ADDENDUM NUMBER ONE

PROJECT: Gilham Elementary School Renovation and Expansion Phase 01
TO: Plan Holders and Plan Centers
FROM: GMA Architects
860 West Park Street Suite 300
Eugene, OR 97401
SUBJECT: Changes, Revisions, Clarifications, and Additions
DATE: 26 February 2016

1 ROOF PLAN - SW
1/8" = 1'-0"

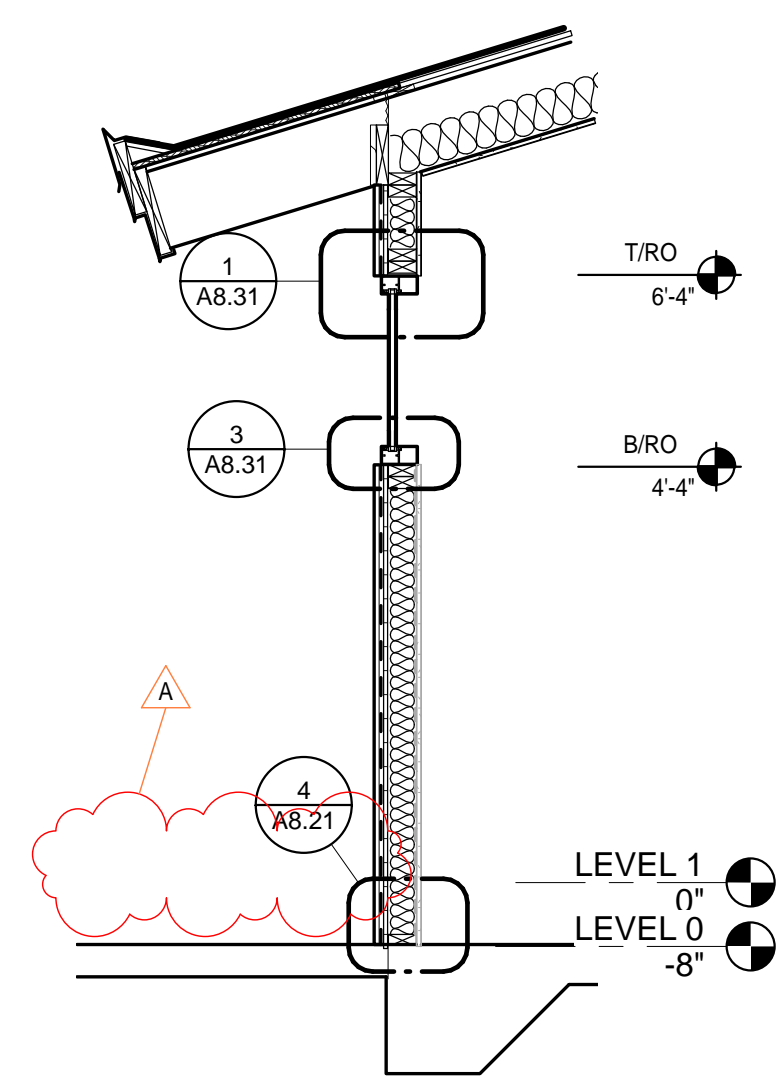
6. Reference Sheet A2.32:

Delete: Sheet A2.32, in entirety.

Add: Revised Sheet A2.32, attached. Revisions are clouded.

8 B129 WEST (A6.10)
1/4" = 1'-0"

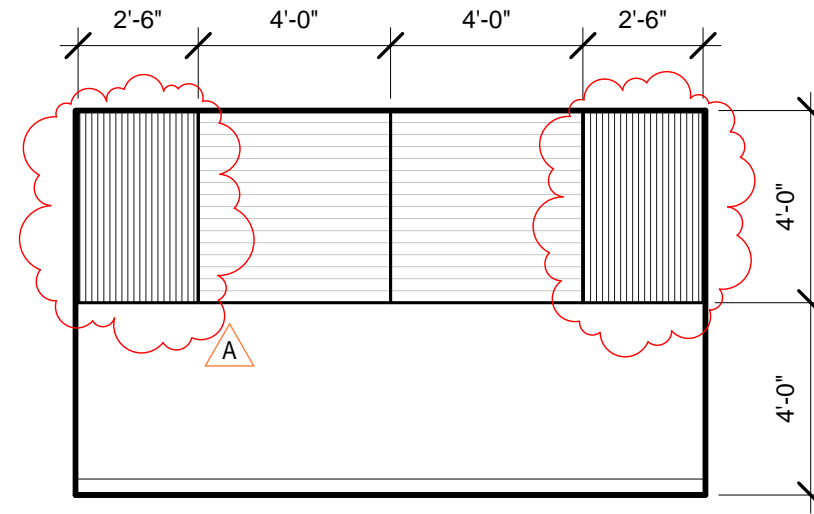
Delete: Drawing 8.

Add: Revised Drawing 8/ADD-1.2, attached. Revisions are clouded.

15 C116 SOUTH (A6.11)
1/4" = 1'-0"

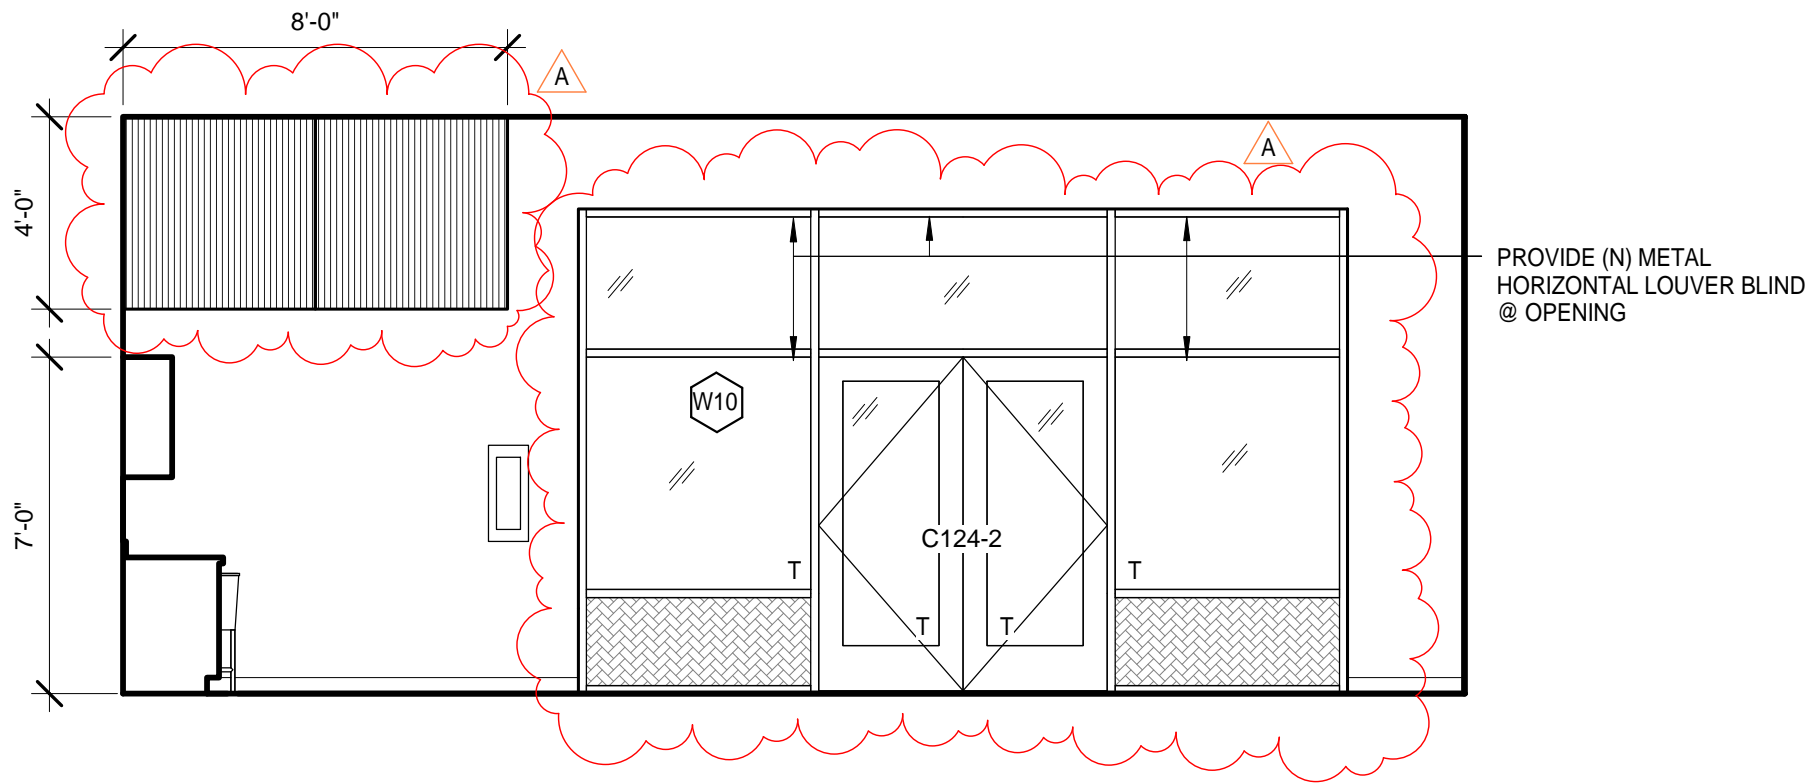
Delete: Drawing 15.

Add: Revised Drawing 15/ADD-1.2, attached. Revisions are clouded.

7 C124 SOUTH (A6.12)
1/4" = 1'-0"

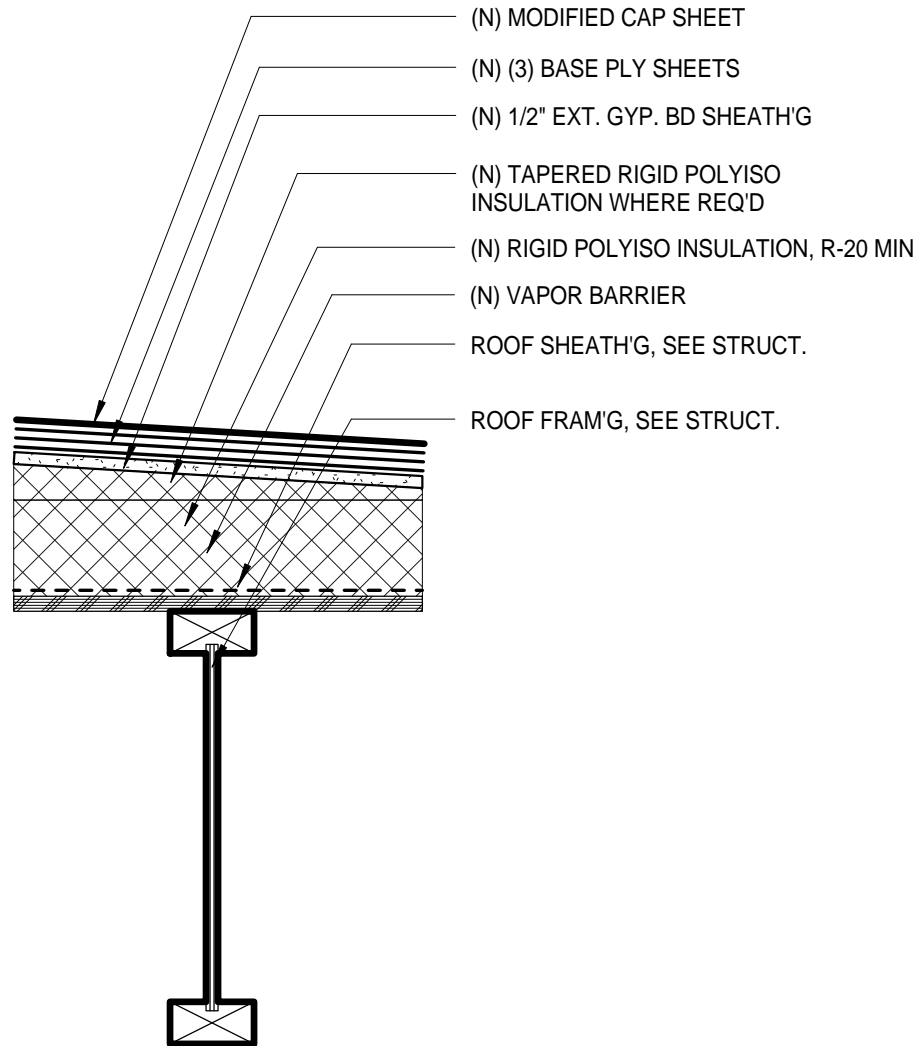
Delete: Drawing 7.
 Add: Revised Drawing 7/ADD-1.2, attached. Revisions are clouded.

R4 (N) BUILT UP ROOF ASSY
1 1/2" = 1'-0"

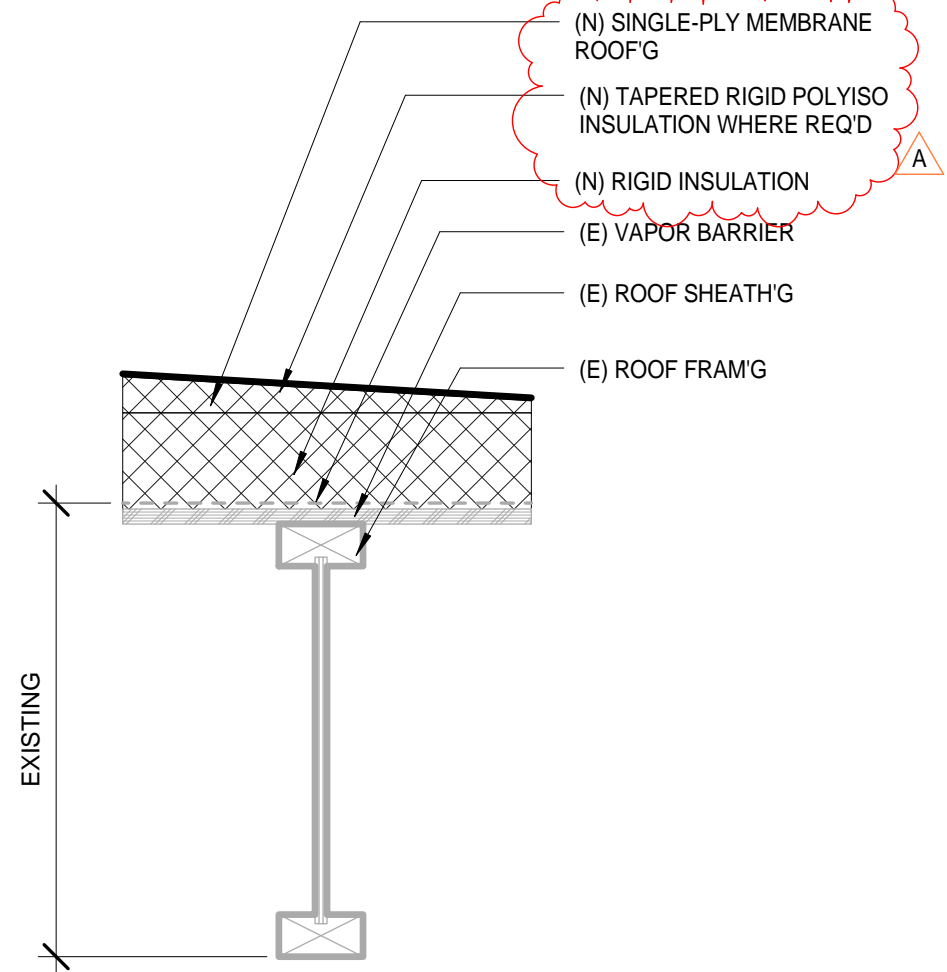
Add: Drawing R3/ADD-1.3, attached. Revisions are clouded.
 Add: Drawing R4/ADD-1.3, attached. Revisions are clouded.

R2 (N) MEMBRANE OVER (E) ROOF ASSY
1 1/2" = 1'-0"

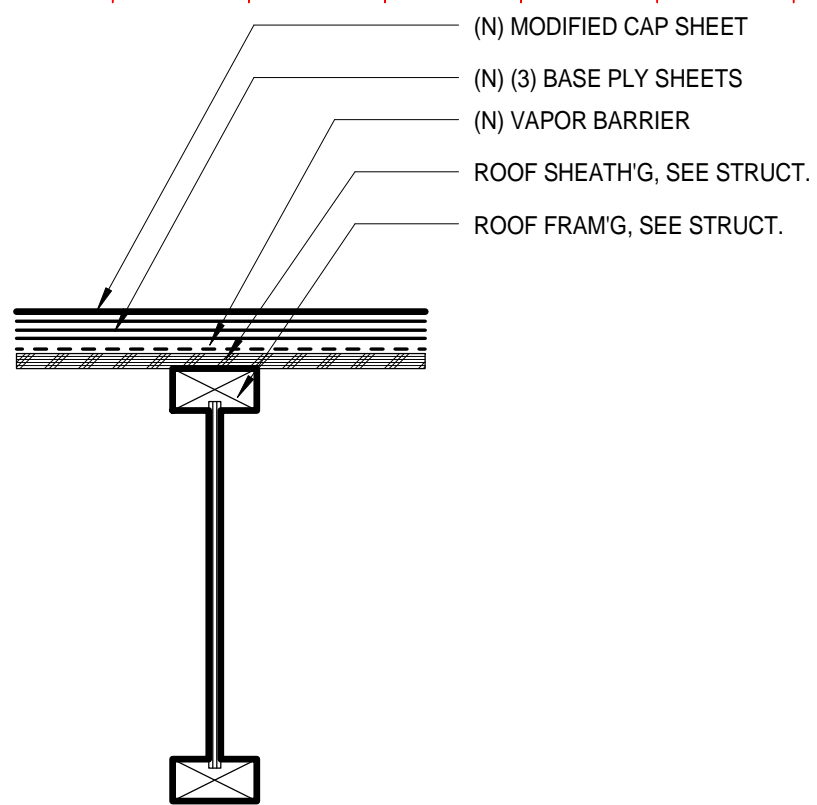
DRAWING R2

Delete: Drawing R2.

Add: Revised Drawing R2/ADD-1.3, attached. Revisions are clouded.

5 **READERBOARD ELEVATION**

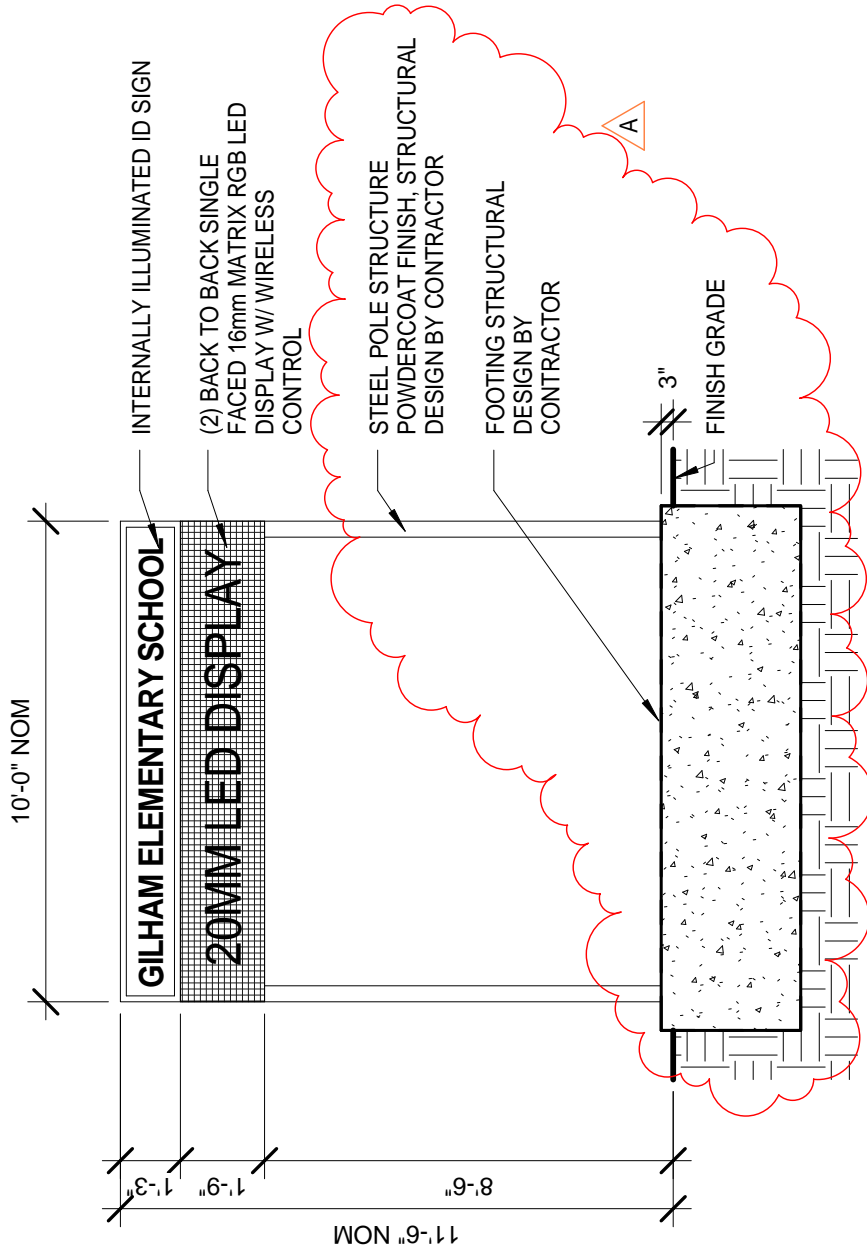
Delete: Drawing 5.

Add: Revised Drawing 5/ADD-1.4, attached. Revisions are clouded.

1 GEN OFF (N) & (E) JOINT
3" = 1'-0"

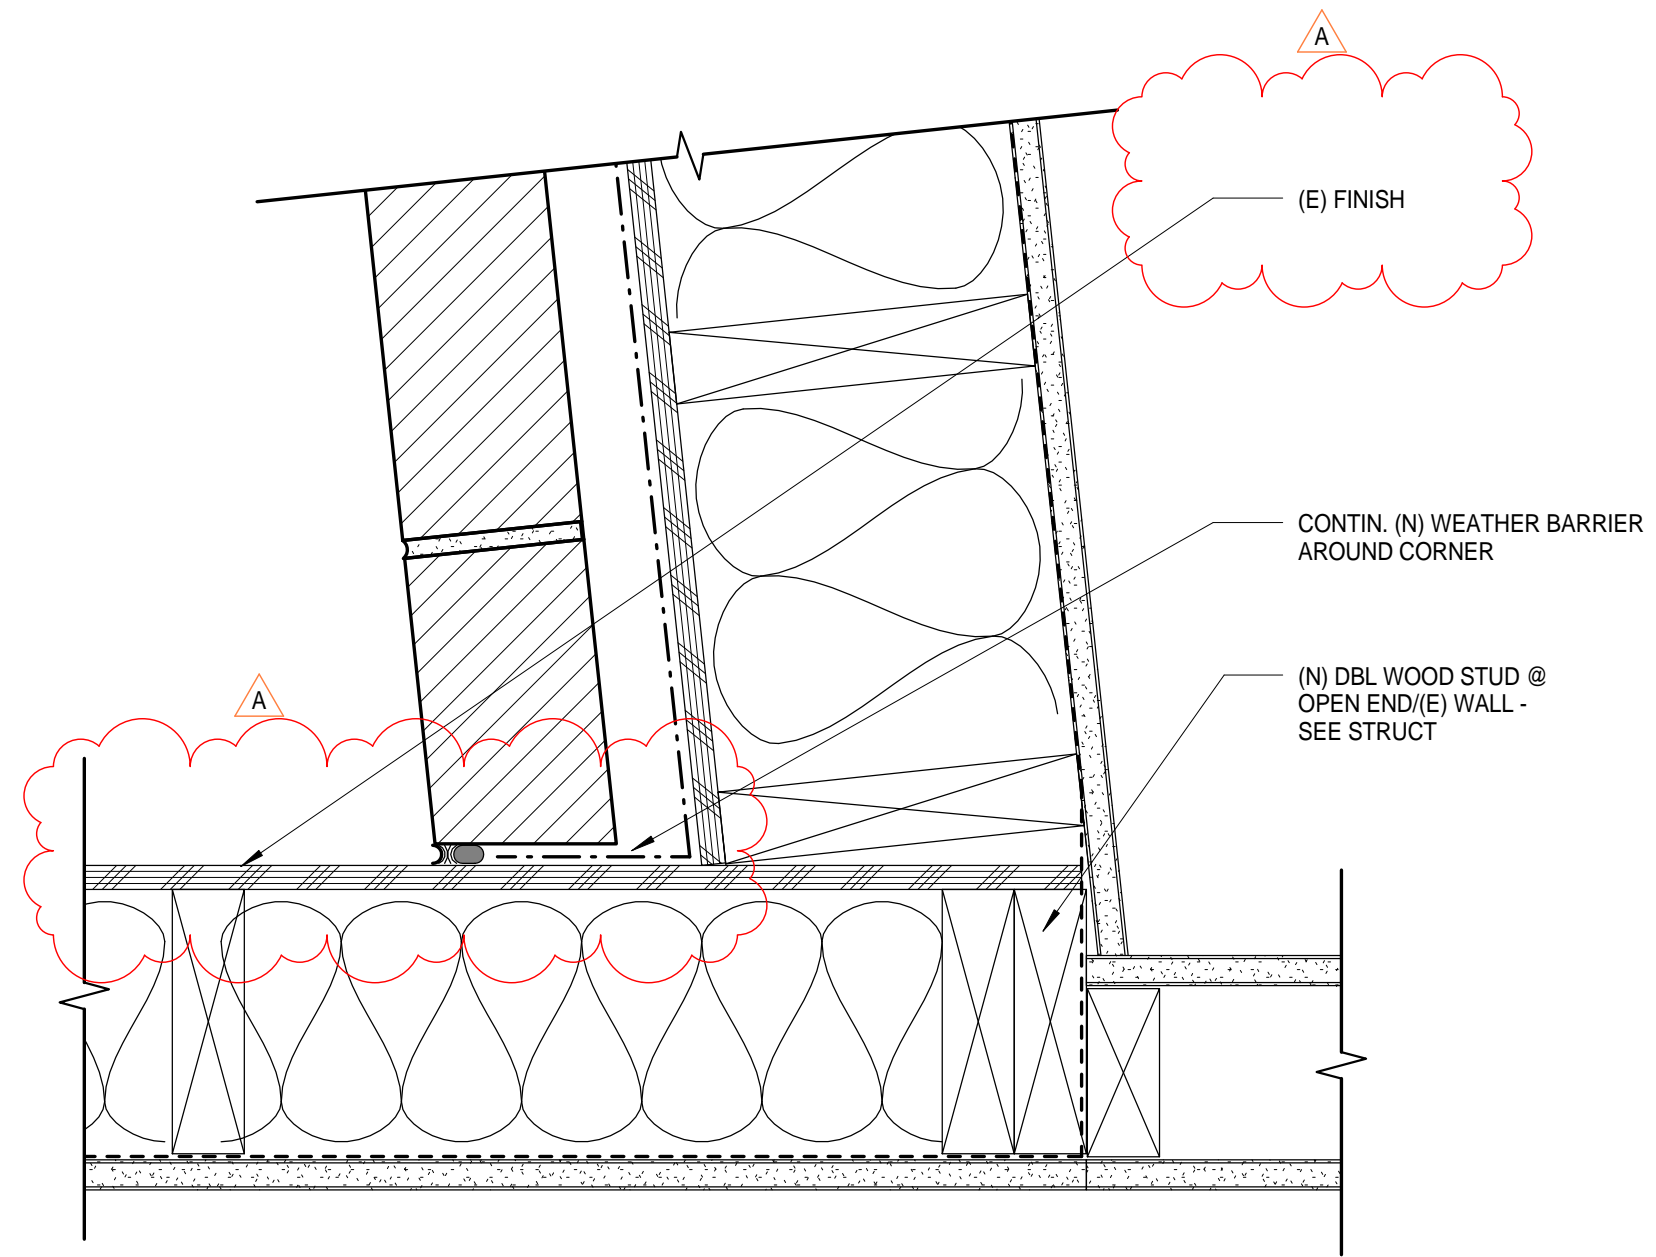
Delete: Drawing 1.

Add: Revised Drawing 1/ADD-1.5, attached. Revisions are clouded.

SHT REF: 4/ A8.50

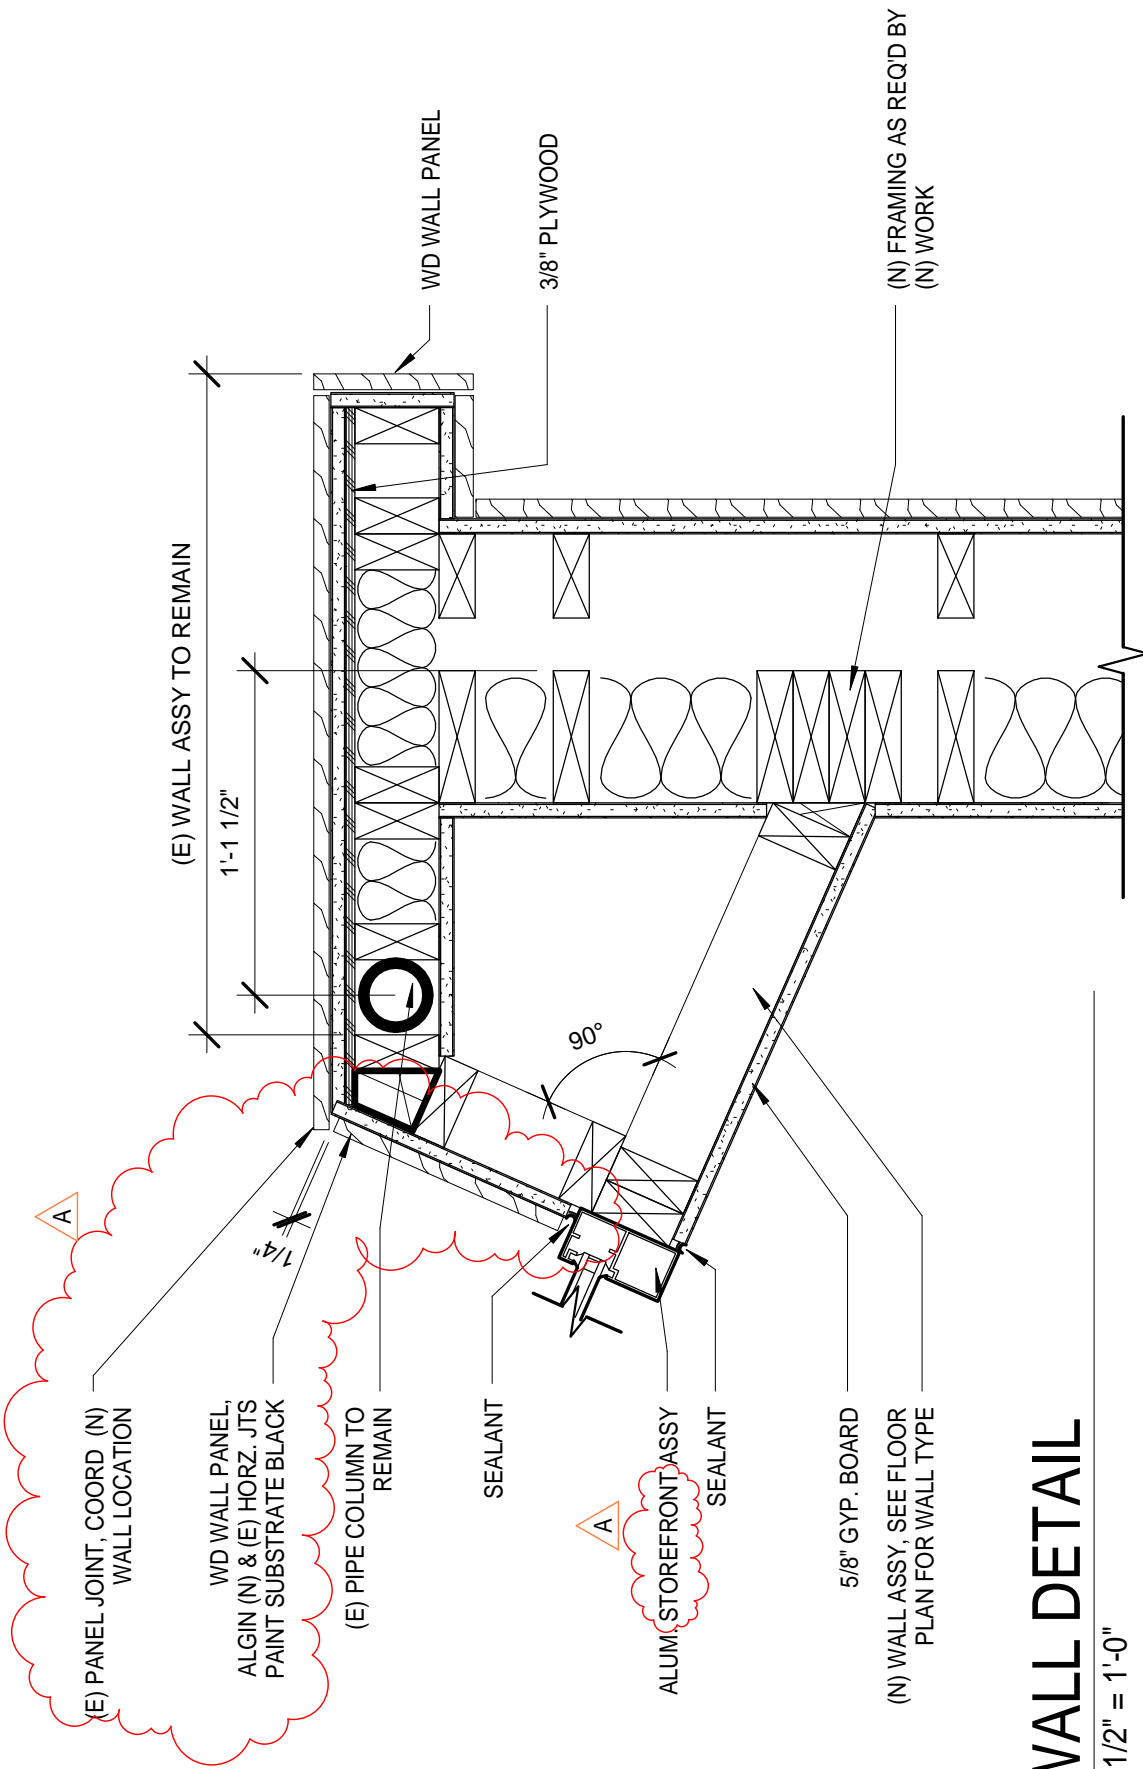
Delete: Drawing 4.

Add: Revised Drawing 4/ADD-1.11, attached. Revisions are clouded.

6 PANEL JOINT_TOP
1 1/2" = 1'-0"

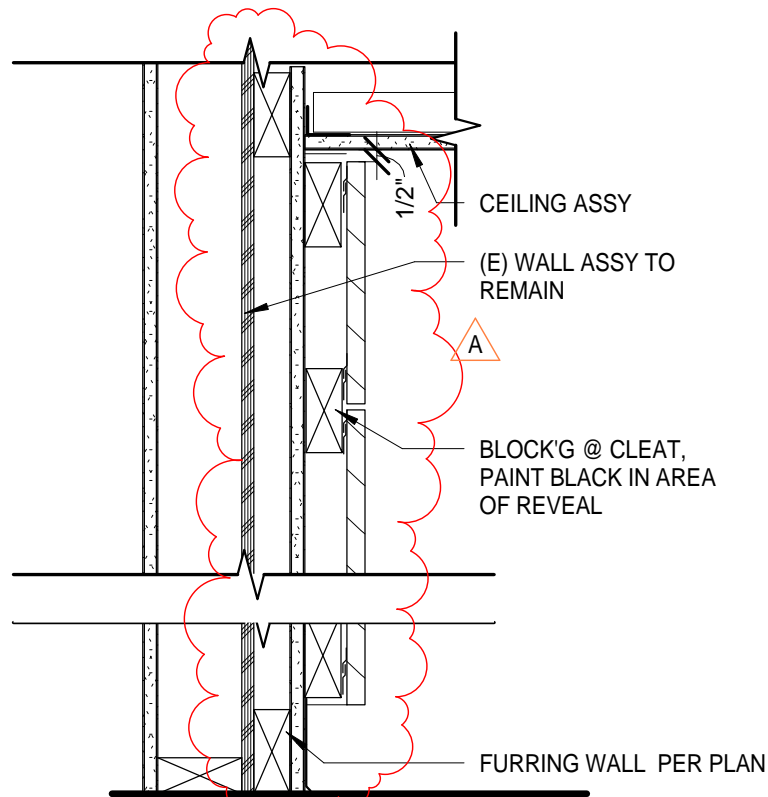
Delete: Drawing 1, 2, 3 and 6.

Add: Revised Drawing 1/ADD-1.12, 2/ADD-1.12, 3/ADD-1.12 and 6/ADD-1.12, attached. Revisions are clouded.
